ENVIRONMENTAL BOARD MEETING MINUTES Wednesday, August 20, 2008

**ENVIRONMENTAL BOARD REGULAR MEETING MINUTES WEDNESDAY,
August 20, 2008**

EXHIBIT 1
SITE PLAN/CUT & FILL LAYOUT
AUSTIN DEL VALLE MOTOCROSS PARK

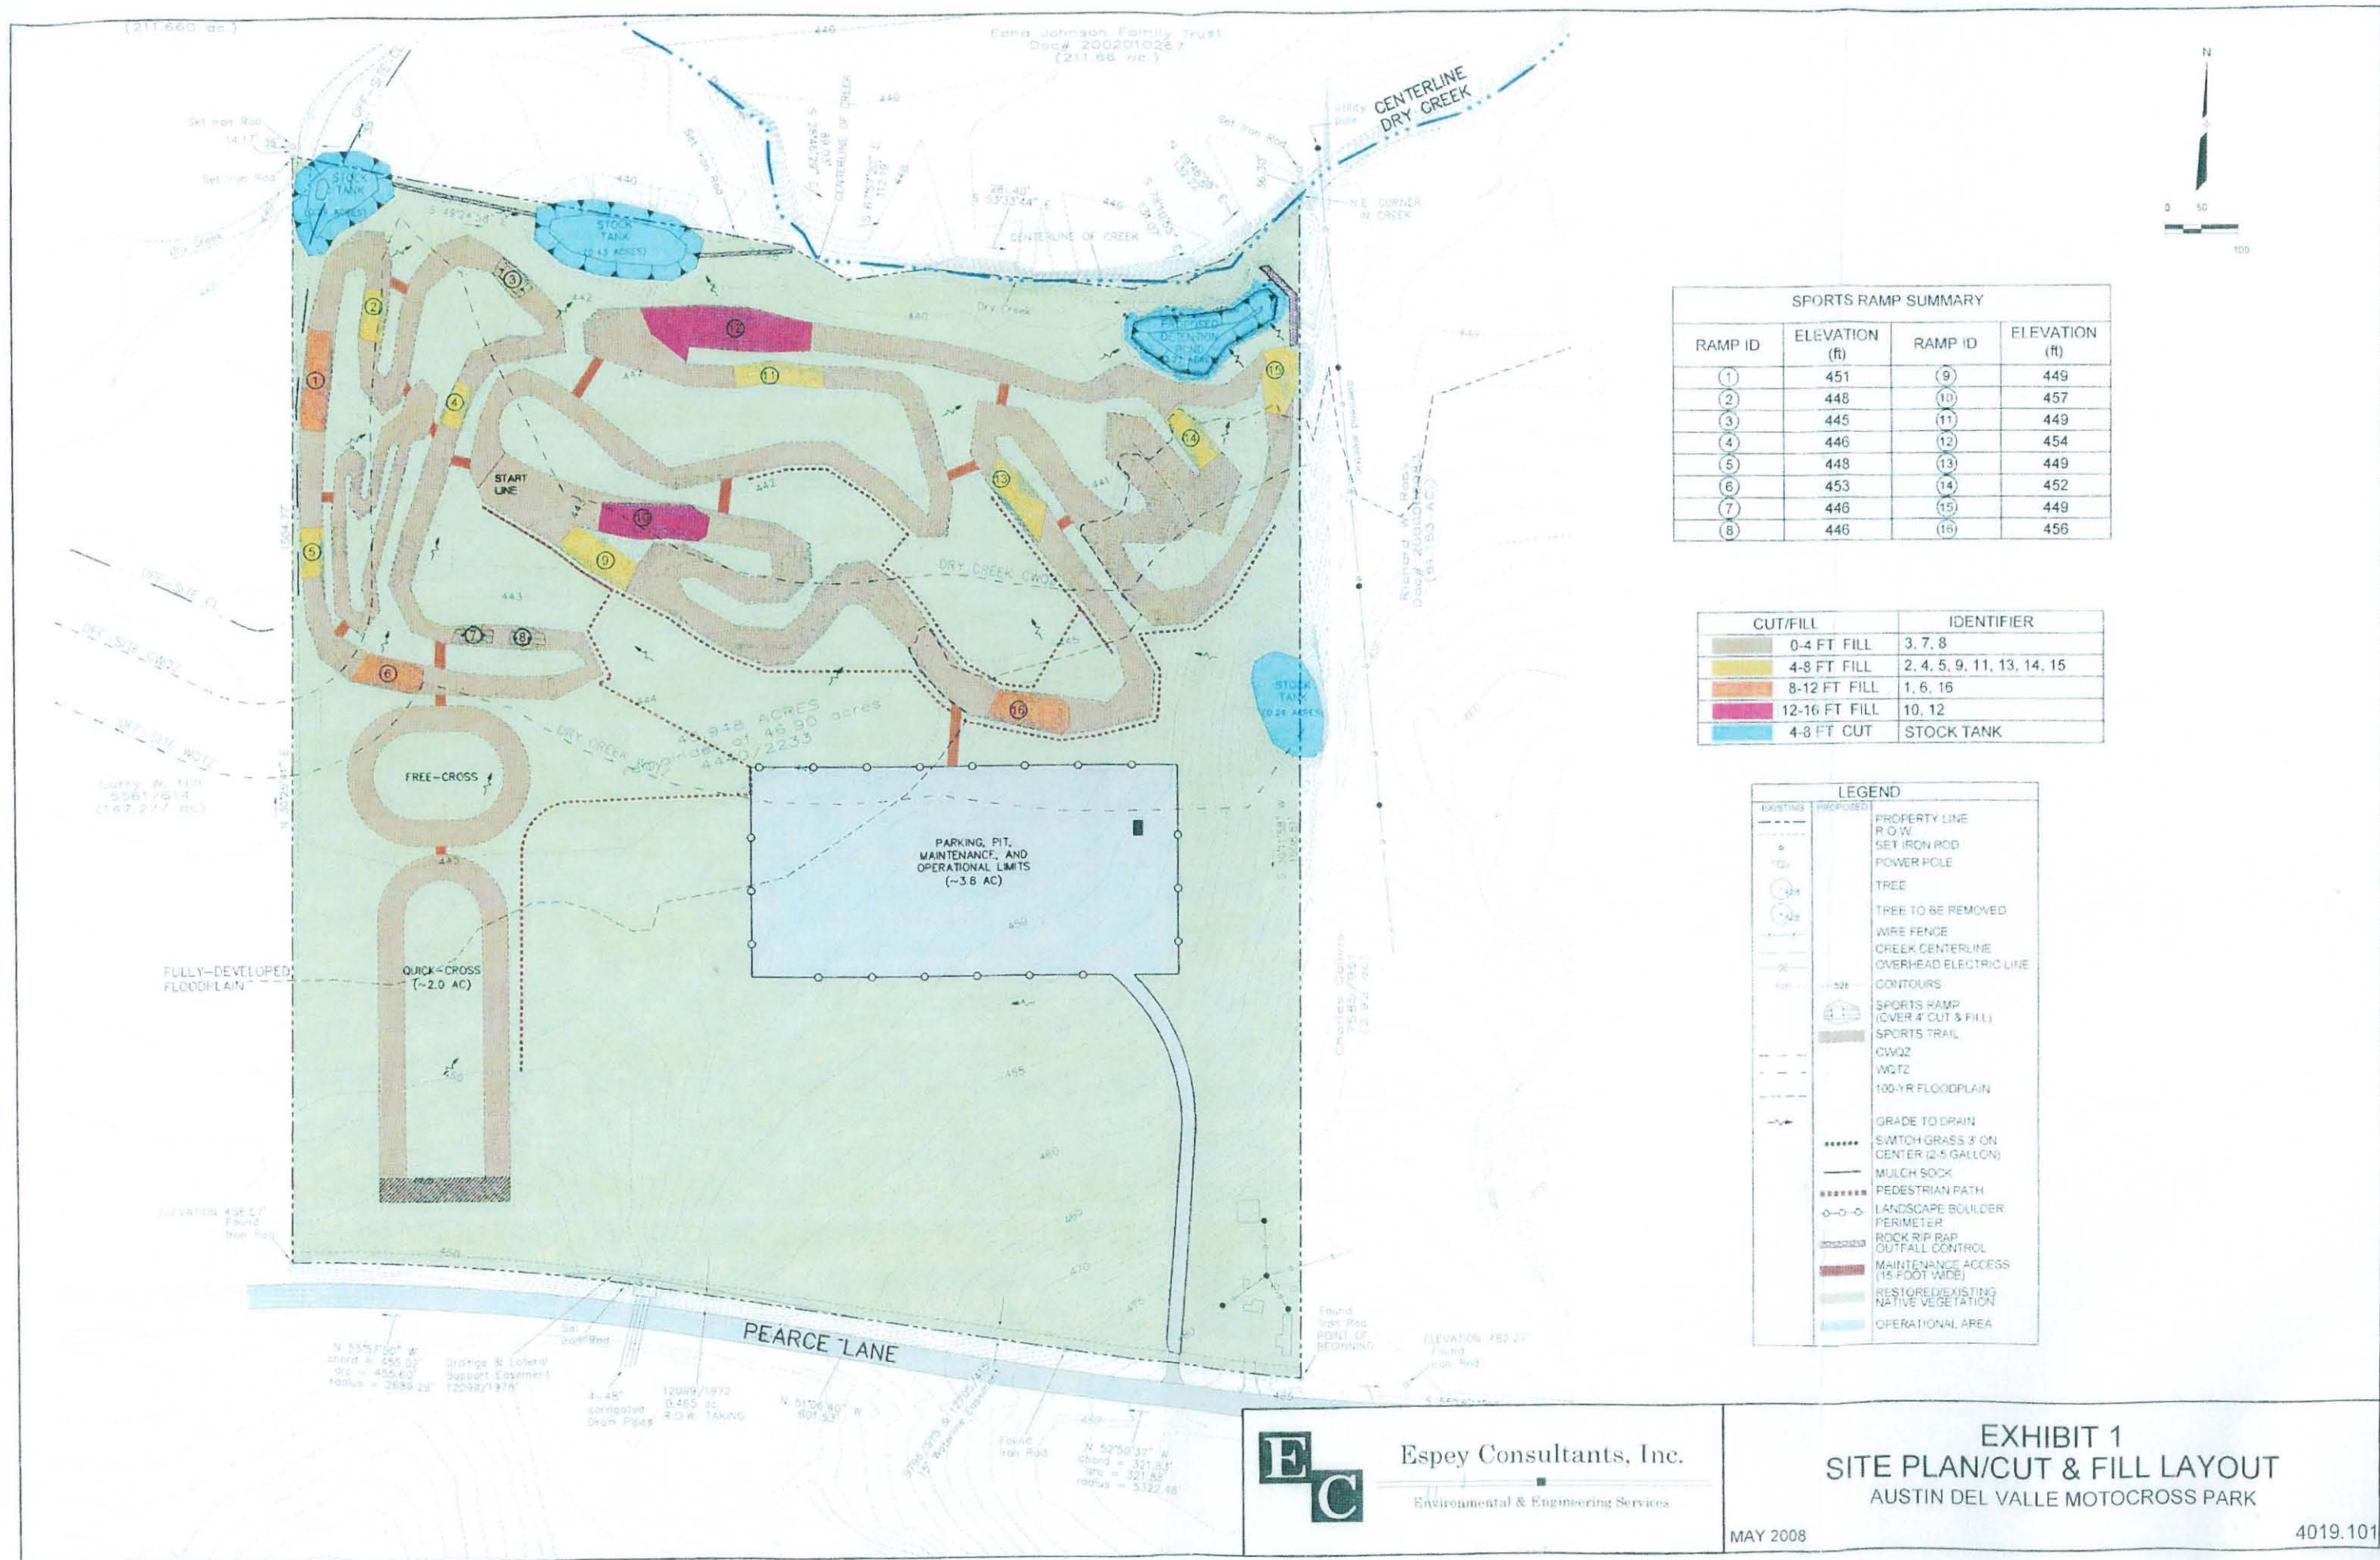
Variance requests to: 1) alter the floodplain (LDC 25-7-61(A)(5)(b)); 2) not provide water quality controls per COA requirements (LDC 25-8-211(B)); 3) encroach within wetland critical environmental features and associated setback (LDC 25-8-282); 4) unstabilized fill up to 16 feet (LDC 25-8-342); 5) construct up to 3.59 acres of impervious cover (track) and construct water quality controls within the CWQZ (LDC 25-8-392); and 6) exceed 30% impervious cover in the WQTZ by constructing up to 2.61 acres (11,362 square feet) impervious cover, 1.74 acres (75,795 square feet) of which is in the 100 year floodplain, 1.74 acres (75,795 square feet) of which is in the 100 year floodplain (LDC 25-8-393(A)).

- 1) alter the floodplain (LDC 25-7-61(A)(5)(b));
- 2) not provide water quality controls (LDC 25-8-211(B));
- 3) encroach within wetland critical environmental features and associated setback (LDC 25-8-282);
- 4) unstabilized fill up to 16 feet (LDC 25-8-342);
- 5) construct up to 3.59 acres (156,380 square feet) of impervious cover (track), and construct water quality controls within the CWQZ (LDC 25-8-392); and
- 6) exceed 30% impervious cover in the WQTZ by constructing up to 2.61 acres (11,362 square feet) impervious cover, 1.74 acres (75,795 square feet) of which is in the 100 year floodplain (LDC 25-8-393(A)).

No The nature of a motorcross cross track requires steep hill and valley topography. In order to achieve this topography, the applicant is proposing fill up to 16 feet in certain areas of the track. The development method does not provide greater overall protection than is achievable without this variance.

1. Implement a track maintenance plan as approved by staff through a restrictive covenant;
2. Revegetate the project area with COA specification 609S for seeding and planting and 604S for seeding as indicated in the approved plan set.

3. Provide permanent mulch sock on the downstream perimeter of the track, and vegetate with COA specification 604S for seeding as indicated in the approved plan set.

4. Enhance the existing wetlands associated with the stockponds using COA specification 609S for seeding and planting as indicated in the approved plan set.
